**SITE PLAN APPROVAL**  
 DISTRICT R200R USE SED  
 #BEDROOMS 3  
10/6/17  
 Date Zoning Administrator

PROPOSED SUBSURFACE WASTE DISPOSAL SYSTEM DETAIL SHEET

SUBDIVISION: OAKMONT

LOT 184

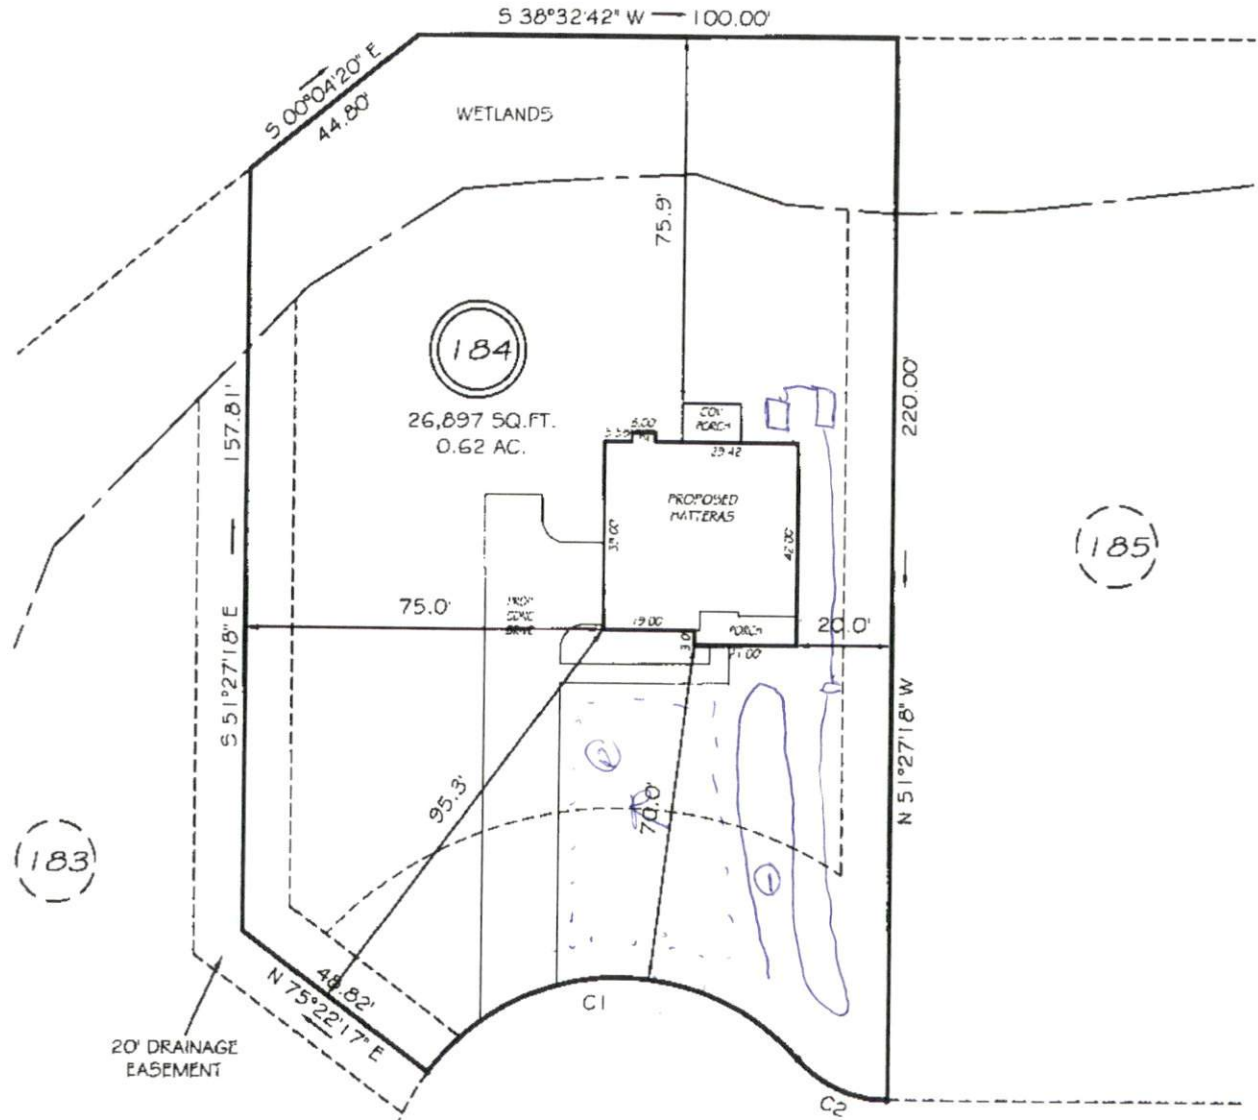
*NEED 80' FRONT SETBACK*
